2006 Chevrolet EQUINOX

Subject: LNJ Service Engine Soon (SES) Light On, Multiple Powertrain Control Module (PCM) Diagnostic Trouble Code (DTC) P1404 and/or P0404 (Install EGR Valve/Gasket/Pipe/Wiring Harness Connector, Reprogram PCM) #06-06-04-008B - (03/19/2007)

Models: 2005-2006 Chevrolet Equinox

This bulletin is being revised to update the first Important statement in the Correction section. Please discard Corporate Bulletin Number 06-06-04-008A (Section 06 -- Engine/Propulsion System).

EGR Valve Identification

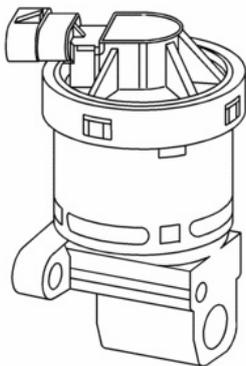
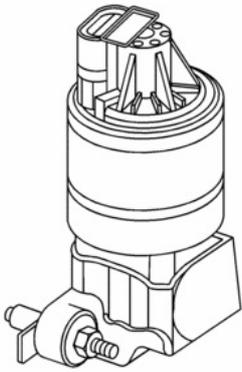
This EGR valve kit is used to convert a Delphi EGR valve equipped LNJ engine used in the Chevrolet Equinox and Pontiac Torrent to a Siemens valve. This kit contains all necessary parts for conversion. The Powertrain Control Module (PCM) calibration must be updated for the Siemens EGR valve to work correctly. Failure to install an updated calibration when using this conversion kit may cause PCM diagnostic codes to set, resulting in a "Service Engine Soon" indicator lamp to illuminate.

Siemens EGR valves have a horizontal electrical connector.

Delphi EGR valves have a vertical electrical connector.

If a *Siemens* valve is *already* installed, it is *NOT* necessary to install this kit. Individual components are serviced.

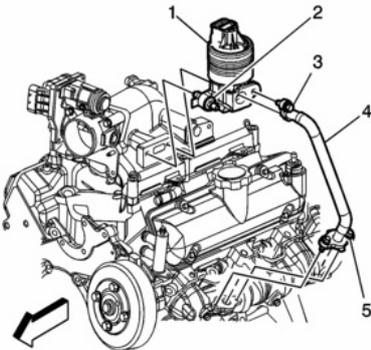
3. Disconnect the EGR valve electrical connector.
4. Remove the bolt (3) retaining the exhaust gas recirculation (EGR) pipe (4) to the EGR valve (1).
5. Remove the 2 bolts (5) securing the EGR pipe (4) to the exhaust manifold.
6. Remove the EGR pipe to exhaust manifold gasket.
7. Remove the EGR valve bolts (2).
8. Remove the EGR valve (1).
9. Remove the EGR valve gasket.

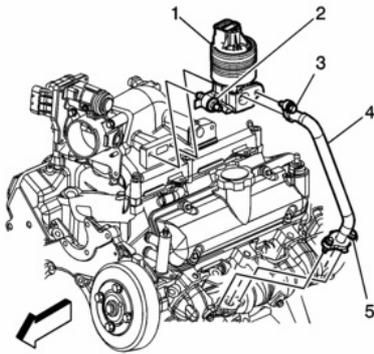
11. Install the new EGR valve, P/N 12581876 (1) with a new EGR gasket, P/N 12593632 to the intake manifold.
12. Install the EGR valve bolts (2).
13. Install the EGR valve bolts (2). Refer to the Fastener Notice in the Service Manual.

14. Install the new EGR pipe (4), P/N 12602507 to the exhaust manifold.
15. Install the 2 bolts (5) that secure the EGR pipe (4) to the exhaust manifold.

16. Install the bolt (3) that secures the EGR pipe (4) bolt to the EGR valve (1).

Tighten the EGR valve bolts (2) to 30 N·m (22 lb ft).

Tighten the EGR pipe assembly bolts to 10 N·m (89 lb in).

Tighten the bolt to 30 N·m (22 lb ft).

EGR Valve Wiring Harness Connector End View Schematic

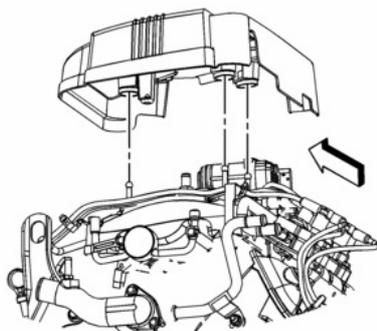
In the following steps, care must be taken to prevent cross-wiring of the two gray colored EGR wire leads (located at pin A and pin D). Cross-wiring will result in an MIL to be set. Before cutting the wiring harness leads, mark the gray leads using tape so the location will be remembered on assembly.

Use splice seal connectors supplied in the wiring harness kit (P/N 15306175) when replacing the EGR valve wiring harness connector.

19. Install the new EGR valve wiring harness connector, P/N 15306175 (includes splice connectors, terminals and wire leads), to the existing engine wiring harness.
20. Use a heat gun to shrink the tubing and set the glue in the connectors.
21. Wrap the new EGR valve wiring harness leads with electrical tape and secure them into the EGR valve electrical harness conduit.

Connector Part Information		5-Way F Metri-Pack 150 (Black)		
Pin	Wire Color	Circuit Number	Function	
A	Gray	435	EGR Solenoid Low Control	
B	Tan	2753	Low Reference	
C	Brown	1456	EGR Valve Position Signal	
D	Gray	5047	5-Volt Reference	
E	Orange	1676	EGR Solenoid High Control
